Re: 24-25-03PD - Jurupa USD Districtwide Exterior Cameras – Addendum #2

**ITEM #4      Revisions to Plans (*Revised Plans attached below*):**

Jurupa Unified Districtwide Camera Project - Camera Schedule by Site\_Addendum 02

T1.01

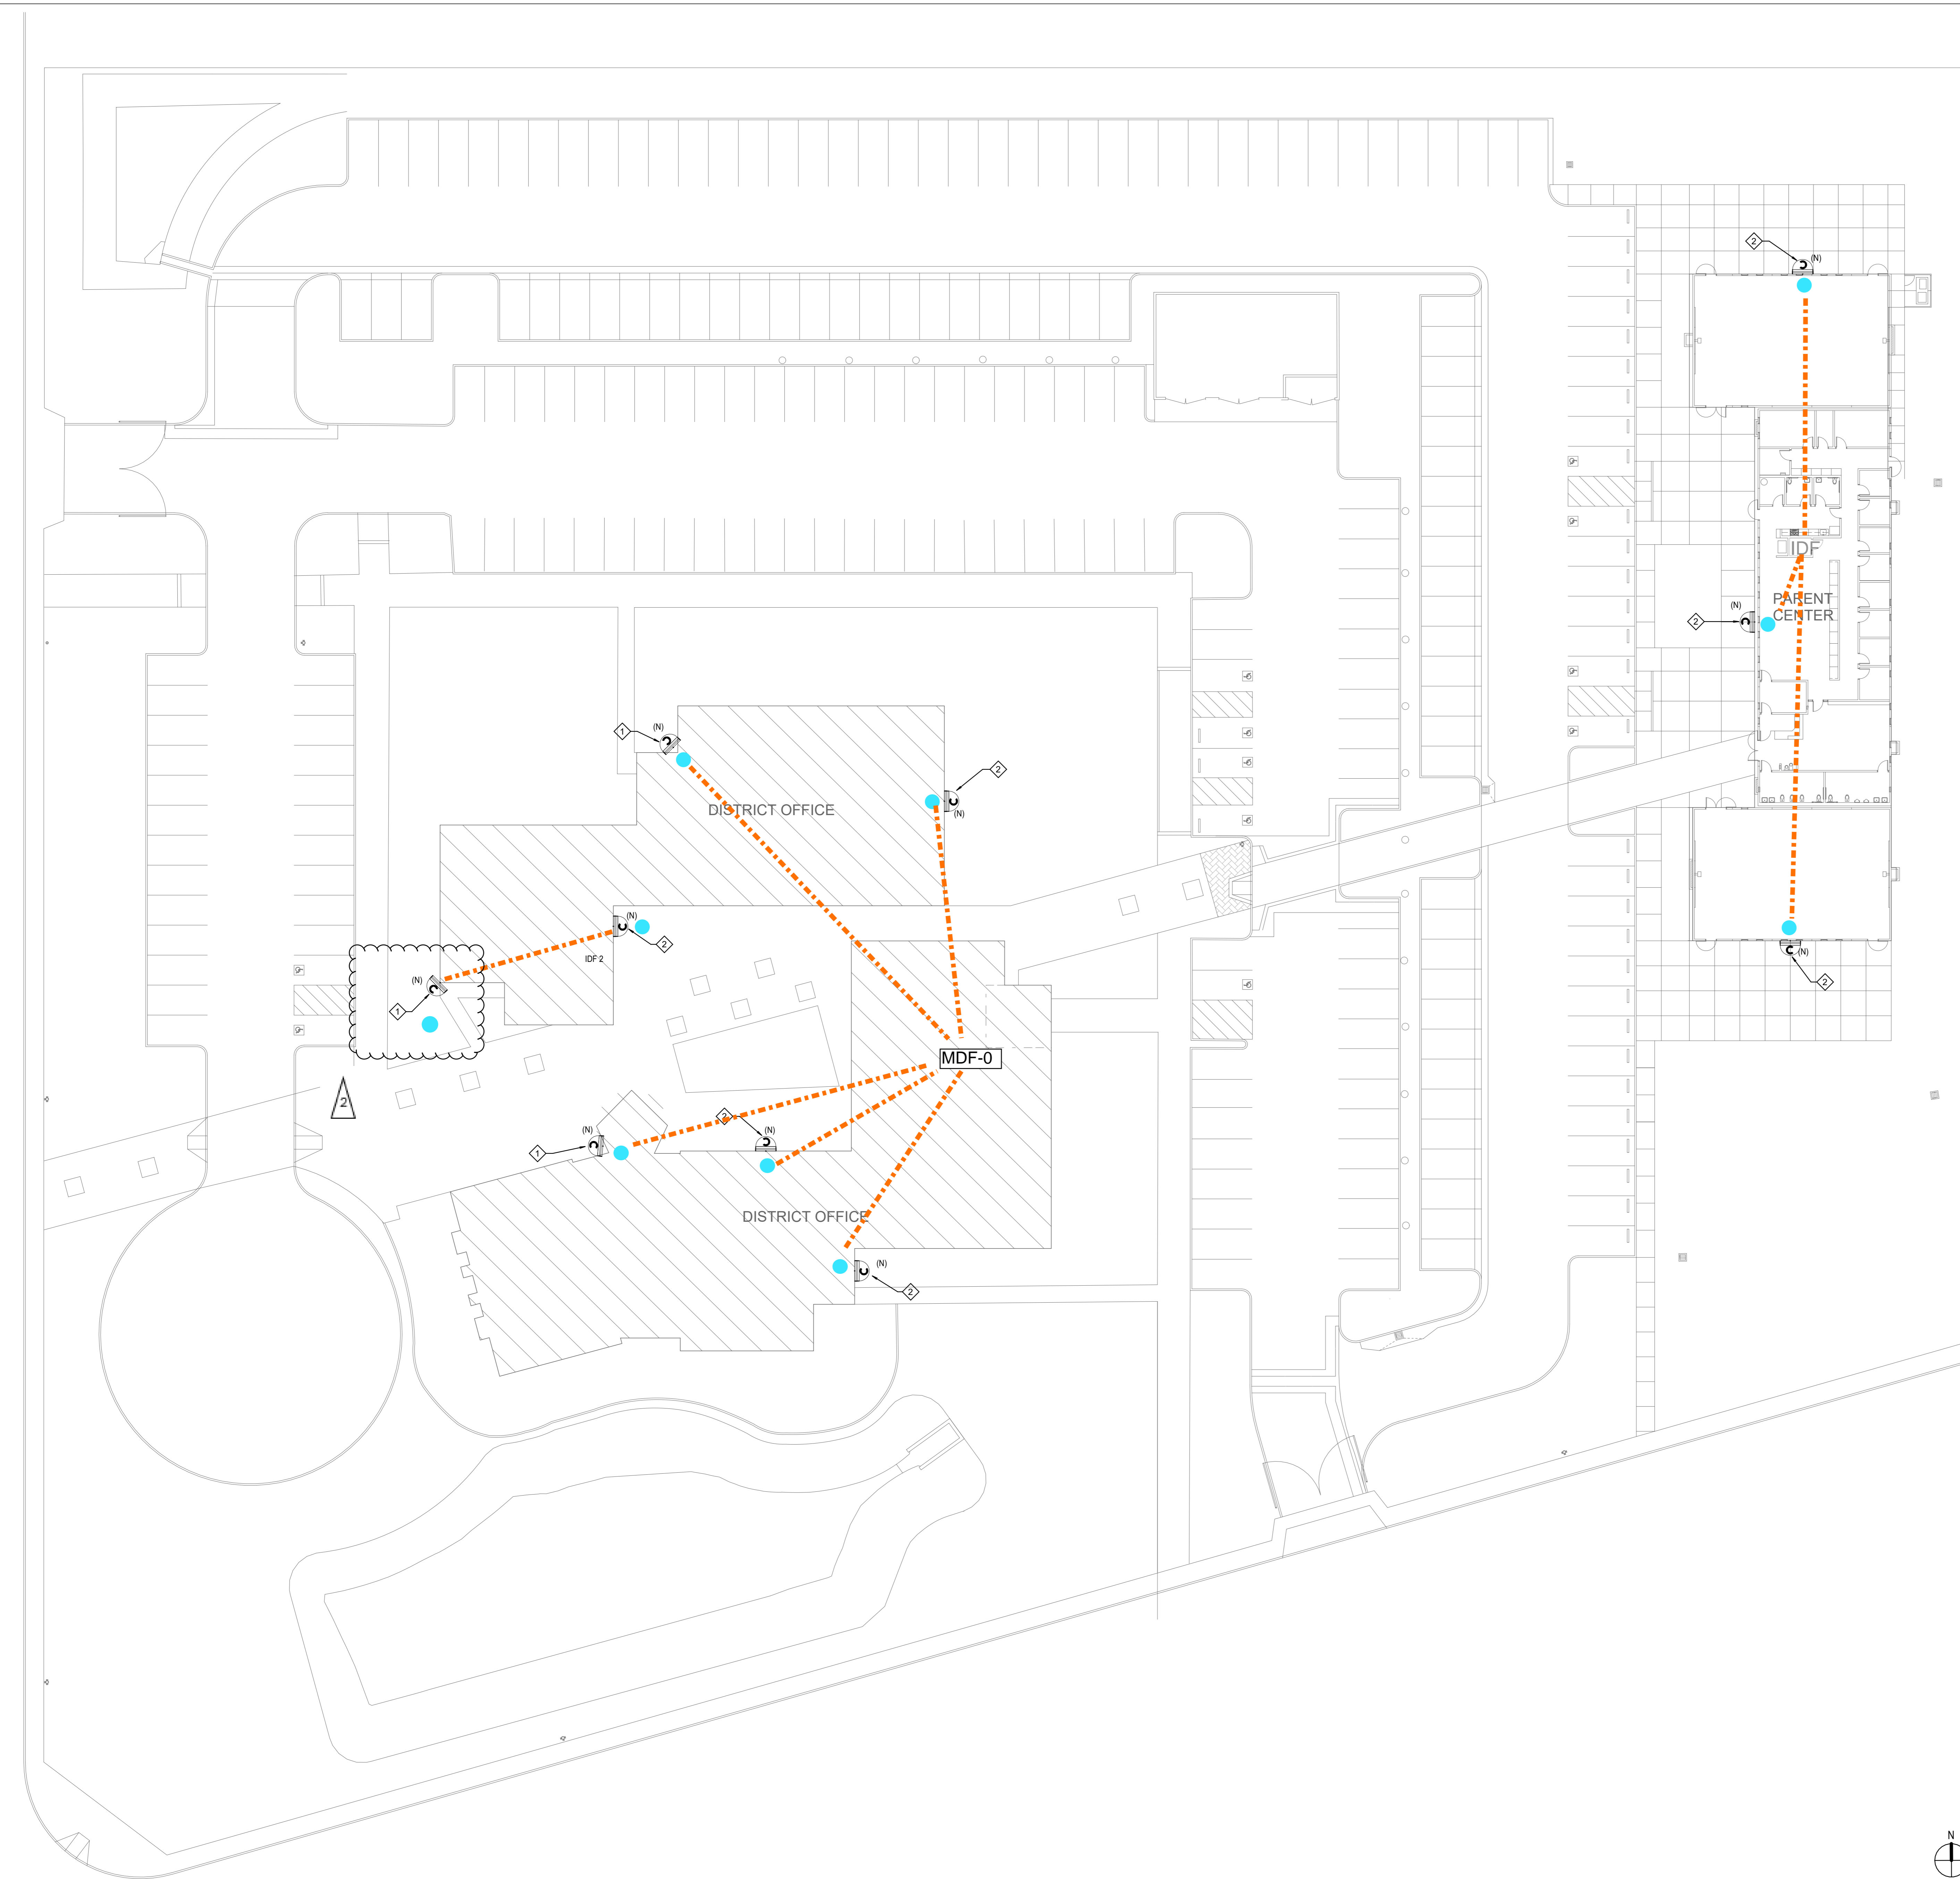
**Question:** The Education Center & Parent Center has 10 Cameras in the Table but only 9 in the Floorplan. Should we quote 9 or 10 cameras? What are the specs for the missing camera if yes? (you can provide just field of view)

1. Revised Camera Schedule with updated quantities attached below.
2. Revised Education Center & Parent Center Plan Sheet T1.01 to include one additional (N) camera location with blue dot.
3. Revised Jurupa Valley High School Plan Sheet T1.01 to include locations of six (6) additional cameras. Removed "BIDDERS NOTE." See Camera Schedule for updated quantities.
4. Revised Mira Loma Middle School's T1.01 Sheet.
5. Deleted "BIDDERS NOTE" on Mission Middle School's T1.01 Plan Sheet. See Camera Schedule for updated quantities.
6. Revised Patriot High School Plan Sheet T1.01 to include stadium light pole camera locations, camera types, and Detail #8 regarding mounting of bullet cameras on Musco Light Poles. Mounting for multi-sensor cameras at stadium lights shall be per Camera Manufacturer.

**Answer:** The blue dot has been added to the tenth camera on the site plan. See Revised Education Center & Parent Center Plan Sheet T1.01.

T1.01

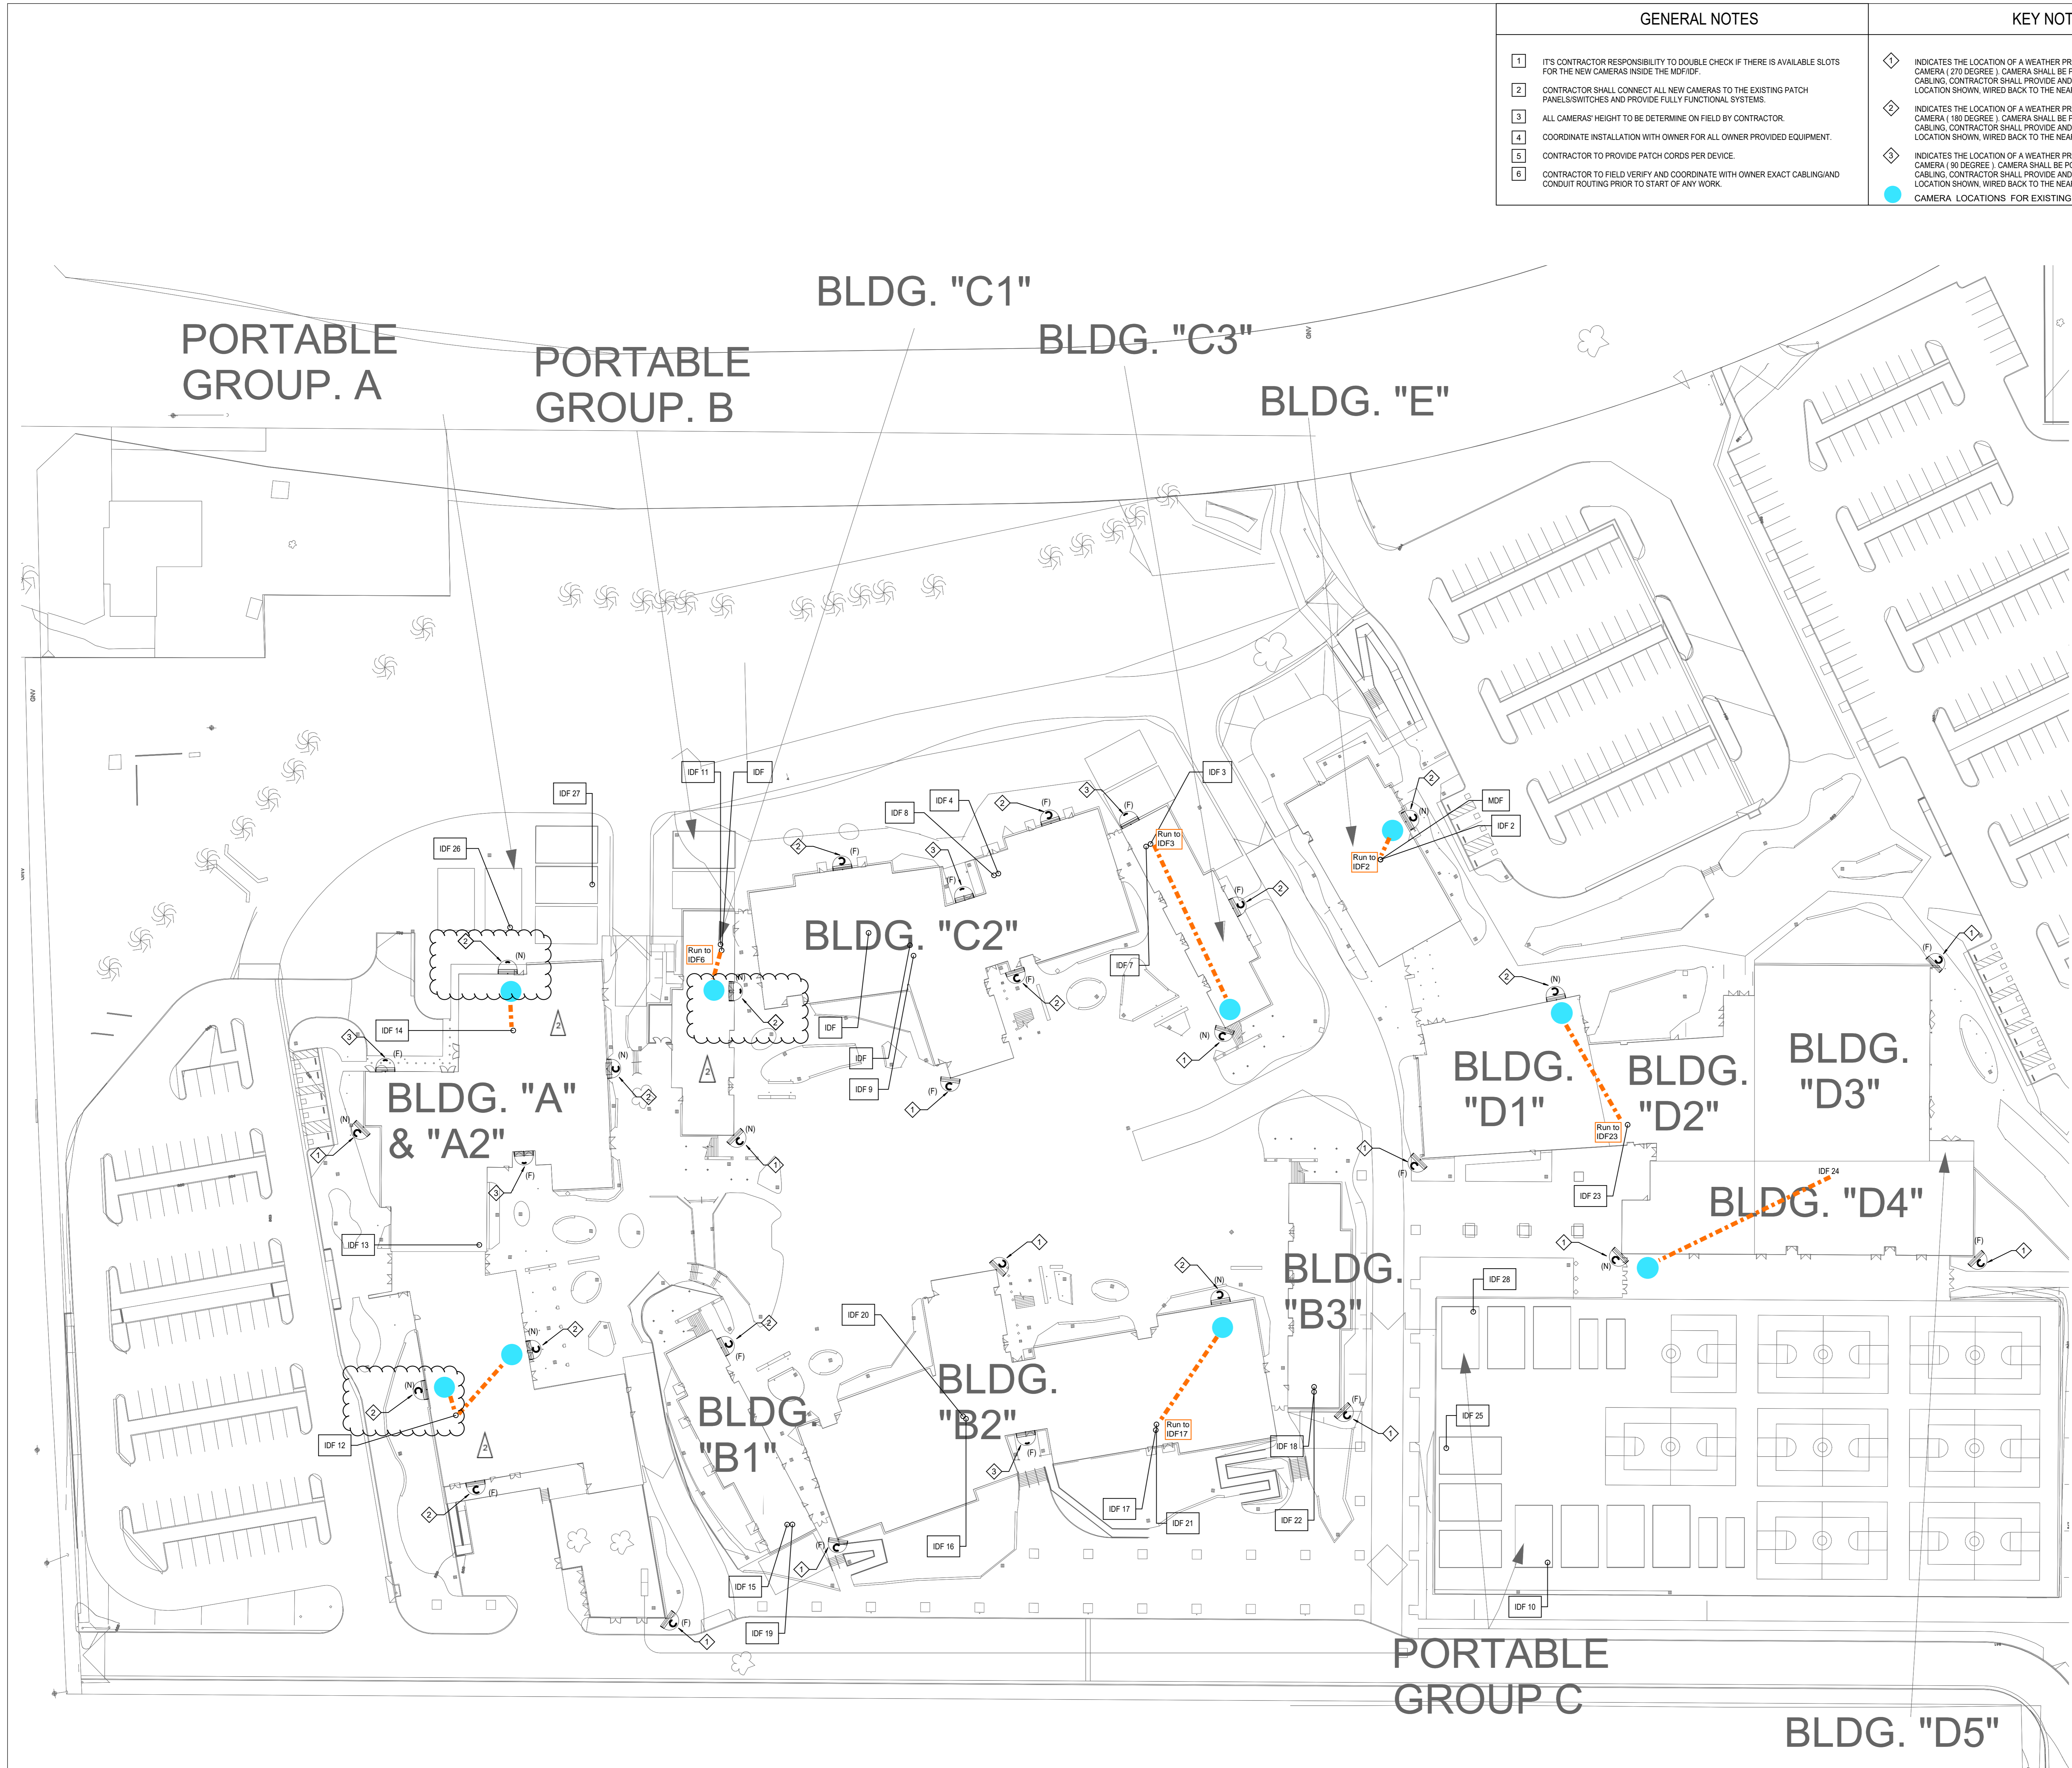
**Question:** Mission Middle School Solar Farm - What camera models does the district want out at the solar farm? What structures are the cameras expected to be mounted to?

**Question:** Mission Middle School will have 10 cameras in Addendum 2, says they will not have data conduit. Should we assume they need power / data from Cellular Gateway?

**Answer:** The 10 additional cameras shown on Mission Middle School Plan Sheet T1.01 have been removed from scope. See Addendum 2 Plans for revised Plan Sheet and revised Camera Schedule with updated quantities.

**Answer:** The 10 additional cameras issued in Addendum 1 as "Bidders Note" have since been removed via Addendum 2. Please see updated Camera Schedule for updated quantities.
